Proposed Residential
Development, Dalguise House,
Monkstown Road, Co. Dublin

Quality Audit Stage 1

Document Ref:	P23-074-RP-QA-3_01
----------------------	---------------------------

Stage 1 Road Safety Audit

I.2.2 Vertical Hazards for Visually Impaired Pedestrians

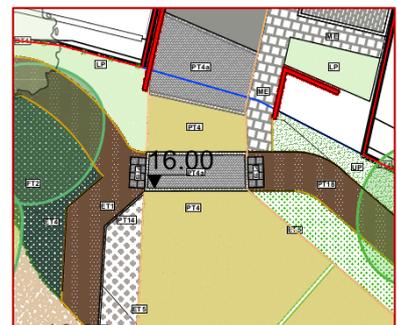
Hazard warning paving has not been indicated at the top and bottom of the steps within the development. This could lead to visually impaired pedestrians being unprepared for the vertical hazard when approaching the steps, resulting in possible trips and falls.

Ensure hazard paving is provided at the top and bottom of all steps within the development.

I.2.5 Unbound Path Surfaces

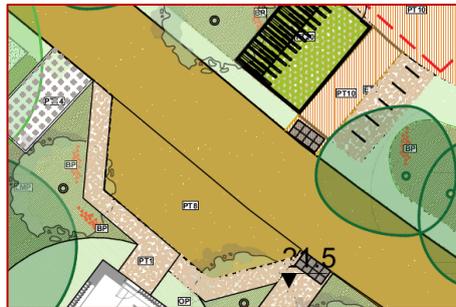
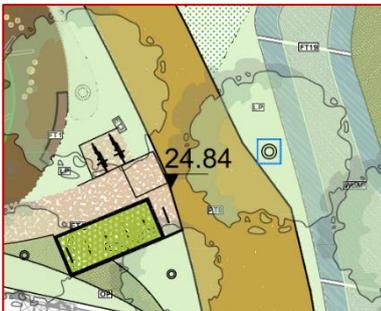
It is proposed to provide unbound “Loose Bark Chip” path material for some of the internal footpaths. The proposed loose bark chip path surfacing would present difficulties for wheelchair users. The unbound material may deteriorate over time, creating unstable or uneven ground, leading to slips, trips or falls.

It is also unclear if unbound surfacing is proposed on the steps along the unbound paths which would also create difficulties for the mobility-impaired and wheelchair users, who would be unable to travel along these paths.

A bound surface footpath should be provided along the paths within the proposed development.

I.2.7 Mobility Impaired Parking Spaces at Southern Extent

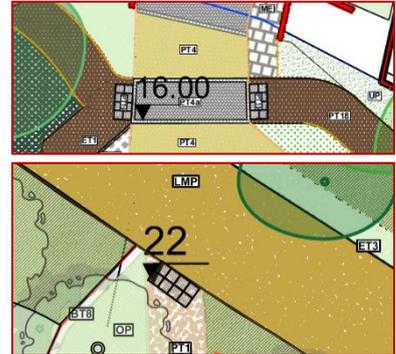
Car parking spaces associated with Block J are located at surface level to the rear of the building. However, no mobility impaired parking spaces have been provided at this location adjacent to Block J. The absence of a mobility impaired parking space may lead to mobility impaired vehicle occupants parking at an alternative accessible parking space and travelling a long distance between their vehicle and the building entrance.

In addition, the mobility parking spaces associated with Block H are located to the rear of the building entrance and would require mobility impaired vehicle occupants a long distance between their vehicle and the building entrance.

Mobility impaired parking spaces should be provided close to their associated buildings main entry point.

II.2.3 Likely Desire Line not Accommodated

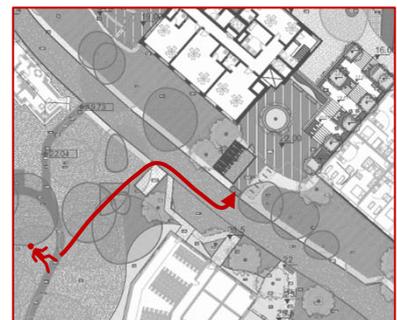
Where NMU routes join the Avenue, which is indicated as a vehicle & cyclist predominant route, the paths do not line up with the likely intended pedestrian desire line, resulting in pedestrians either travelling within the shared path with vehicles & cyclists over a lengthy distance or choosing to travel across the grassed areas where they are at increased risk of slips, trips or falls.

Pedestrian routes should align with the likely pedestrian desire lines to minimise pedestrians interaction with vehicles and cyclists.

IV.4.2 Short-Stay Bicycle Parking Locations

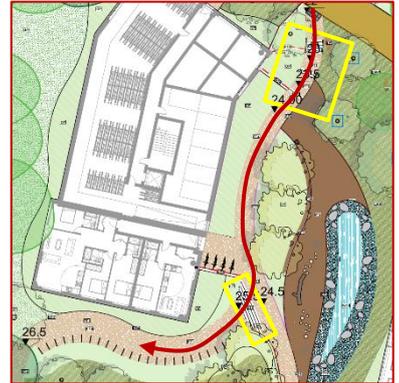
The location of a number of short-stay bicycle parking areas is such that cyclists must travel a lengthy route between the parking spaces and the entrance to their associated Block.

The location of the short-stay bicycle parking spaces associated with Block D and Block G would require cyclists to dismount their bicycle and ascend/descend a series of steps or, alternatively, they must travel a less direct, lengthy, route. This may discourage cyclists from parking their bicycles at these locations and may encourage informal parking on footways, possibly restricting pedestrian access.

Location of short-stay bicycle parking spaces associated with Block E would require cyclists to travel a lengthy distance, on foot within the shared Avenue, between the bicycle stands and the building entrance.

Short-stay bicycle parking should be accessible without cyclists being required to ascend/descend steps and be located no further than 25m from their associated building entry points.

13	Short-Stay Bicycle Parking Locations			IV.4.2		<p>The majority of bike stands would be less than 25m from building entrances, however due to number of stands required/proposed some spaces are up to 36m away. Any stand that exceeds the 25m distance is for long-stay bicycle parking.</p> <p>Please see page 26 of the Landscape RFI response document for further description and Drawing No. C0135 L900 which sets out locations of cycle parking and gives distances to building entrances.</p>

IV.4.3 Narrow Cycle Parking Access Route

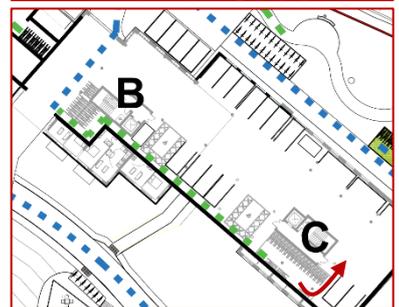
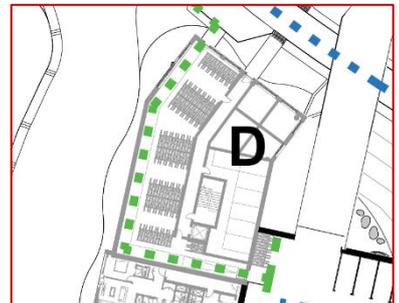
The width of the proposed access routes to long-stay bicycle parking areas within the basement car parks of Block D and Block B & C has not been indicated in the drawings provided. It is therefore unclear if an adequate width would be provided for cyclists to comfortably access/egress the parking areas. Furthermore, the proposed cycle route within the basement car park of Block B & C would require cyclists to travel to the rear of car parking spaces where the route may become obstructed by a parked vehicle. A narrow access route may result in there being insufficient space for cyclists to pass one another.

In addition, cyclists may experience difficulties entering/exiting the long-stay bicycle parking area associated with Block C as they are located in close proximity to car parking spaces.

Cycle parking access routes should be at least 1.5m, preferably 2.0m, wide between walls/fences. A reduced width of 1.2m is acceptable over short distances, i.e. less than 10m

Item No.	Summary of Issue	Individual Audit References				Design Team Response/Action
		Access Audit	Walking Audit	Cycle Audit	Road Safety Audit	
14	Narrow Cycle Parking Access Route			IV.4.3		Dimensions have been included on cycle access drawings and all access routes now meet the guidelines/standards.
15	Mix of Long-Stay Bicycle Stands			IV.4.4		The proposals include a number of larger bicycle parking spaces which cater for cargo bikes or hand-operated bikes at both ground and basement level.
16	Bicycle Stand Sizes			IV.4.5		DLR standards have been followed for all Sheffield bicycle stand spacing.
17	Headroom			IV.4.6	V.3.18	Please refer to Road Safety Audit Feedback Form in Appendix V. Trees would have a clear stem height of 2.5m to 3m when planted and will be maintained.
18	Long-Stay Bicycle Parking Locations			IV.4.7		Block E and Block C secure parking have been configured to allow for ease of access with a minimum clear width of 1.9m between car parking spaces and bicycles.

IV.4.6 Headroom

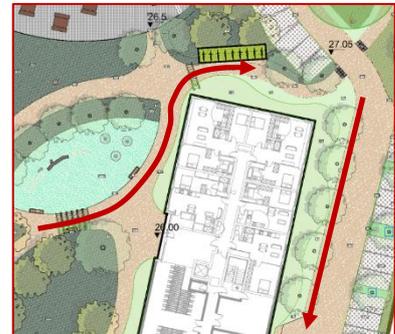
Street trees have been indicated near, or extending over, the shared paths within the proposed development. The vertical clearance between the cycle track and the tree canopies is unclear.

Insufficient clearance to the tree canopies will present a hazard to cyclists, or lead to sudden avoidance manoeuvres by cyclists.

A vertical clearance of 2.5m should be provided on all cyclist routes within the development.

IV.4.7 Long-Stay Bicycle Parking Locations

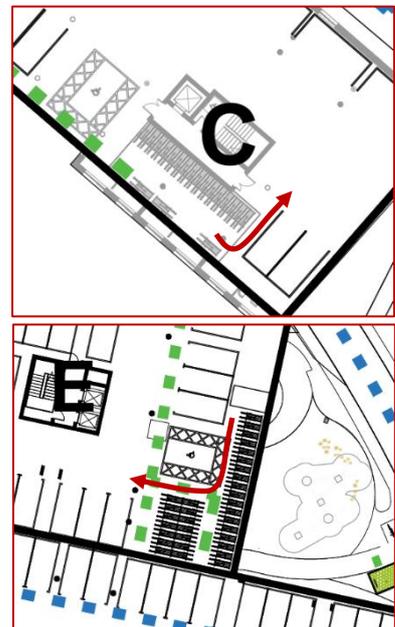
Long-stay bicycle parking areas have been indicated in adjacent to car parking spaces within the basement car parks associated with residential Block C and Block E.

It is unclear if sufficient space would be provided between the bicycle parking stands and the car parking spaces. Should there be insufficient space for cyclists, this create difficulties for access/egress to/from the bicycle parking area, this may discourage cyclists from parking their bicycles at these locations and could lead to them parking within the long-stay bicycle parking spaces provided for residents of other Blocks.

Sufficient space between the bicycle parking areas and car parking spaces should be provided such that cyclists can comfortably enter/exit these areas.

IV.4.9 Ramp Gradients

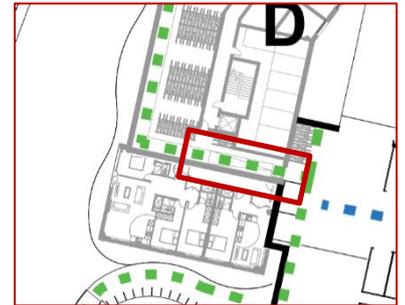
A ramp is indicated within the underground car park providing a link to an area of long-stay bicycle parking. The gradient of this ramp has not been indicated on the drawing provided. If the gradient of the ramp is steeper than 1:20 there is a risk that cyclists may experience difficulties when using the ramp leading to the potential for them to roll backwards or be unable to wheel their bicycle up the ramp.

Access to the long-stay bicycle parking at this location should be facilitated by ramped access with appropriate gradients or elevator access.

19	Security of Long-Stay Bicycle Parking			IV.4.8		All Long-Stay Bicycle parking will be caged with a secure lock.
20	Ramp Gradients			IV.4.9		The ramp will be a 1:21 slope, 42m in length with landings clear of doors.
21	Showers and Lockers			IV.4.10		Showers and Lockers will be provided in the Creche and in Block E for staff located in the scheme.
22	Long-stay Bicycle Parking Area Doors			IV.4.11		Secure doors will be provided with fobbed access to long-stay bicycle parking
23	Sheltered Short-Stay Bicycle Parking			IV.4.13		DLR standard requires a minimum of 108 short-stay bicycle parking stands for the development, 50% of which are to be sheltered. The proposed development would provide 62 sheltered short-stay bicycle parking spaces (57%).
24	Bicycle Maintenance Areas			IV.4.14		Bicycle Maintenance Areas will be provided across the scheme.

IV.4.11 Long-stay Bicycle Parking Area Doors

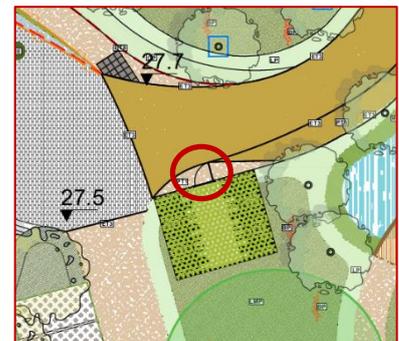
It is unclear from the information provided whether there are doors along the routes to/from the underground bicycle parking areas, and, if there are, whether they are manually operated or powered.

Manually operated doors may present difficulties for cyclists accessing/egressing the underground parking area.

Doors used by cyclists should be operated electronically by automatic detection or with the push button 3m from the door.

Location: Junction east of Dalguise House

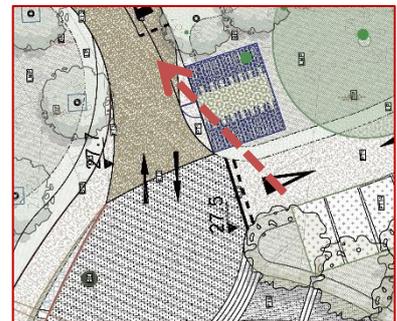
Summary: Visibility at the internal junction may result in unsafe exiting manoeuvres.

The internal road which will provide access to Blocks I (East) and I (West) intersects with the main access road at a junction to the north of Block H.

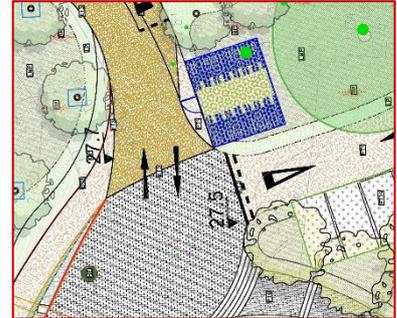
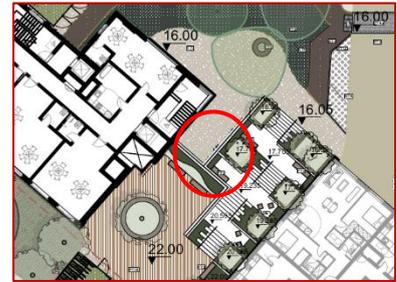
Summary: Cyclists entering/exiting the proposed bicycle shelter may be at risk of being struck by a vehicle.

The proposed secure bicycle parking area is indicated in close proximity to the Avenue carriageway at a location where inbound vehicles must move into the path of oncoming vehicles when entering the plaza area in front of the House.

The door on the cycle shelter is indicated as opening towards the Avenue, and close to the possible path of vehicles. This could lead to cyclists opening the door ahead of oncoming vehicle or stepping out on the shared path in front of an oncoming vehicle.

The bicycle shelter should be re-positioned so that a landing area can be provided at the door so that cyclists can enter/exit without encroaching onto the adjacent carriageway.

3.11 Problem

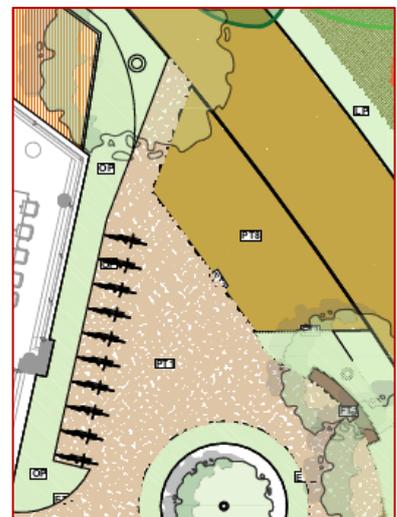
At a number of locations throughout the development level differences are indicated. It is unclear from the information provided if edge protection is proposed at these locations. A lack of edge protection may result in pedestrians falling from height, resulting in personal injury.

During the design development edge protection should be provided at all locations where there is a risk of falls from height.

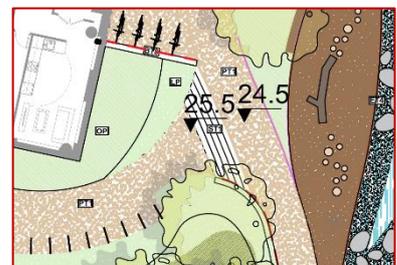
It is unclear what, if any, public lighting is proposed along the main Avenue. This is a route which is to be shared by vehicles, cyclist & pedestrians and an absence of adequate lighting, in particular during the winter months, could lead to an increased risk that drivers or cyclists may fail to see a pedestrian in the road ahead resulting in increased risk of vehicle/cyclist collisions with pedestrians.

During the design development measures should be included to ensure that the proposed development is sufficiently lit and that lighting columns are located such that they do not present obstacles to vulnerable road users.

3.15 Problem

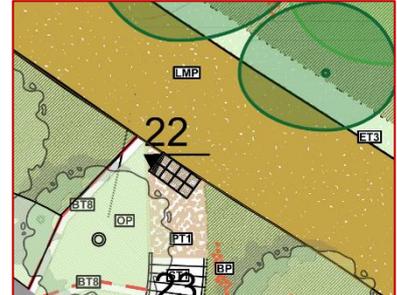
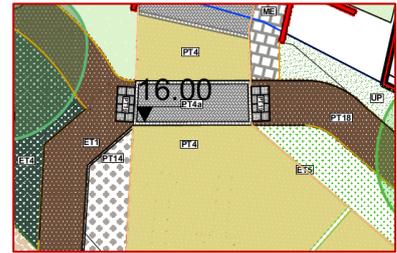
Hazard tactile paving should be provided at the top and bottom of steps.

3.16 Problem

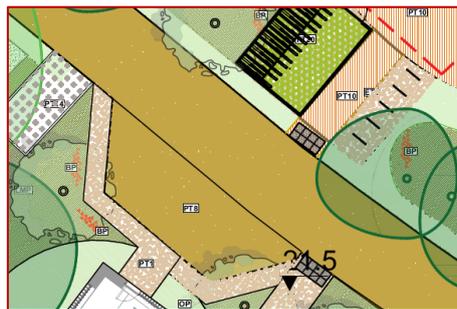
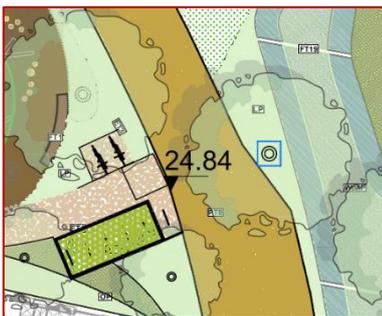
Tactile paving should extend at least 1.2m from the kerb edge at in-line uncontrolled crossings across the full width of dropped kerb.
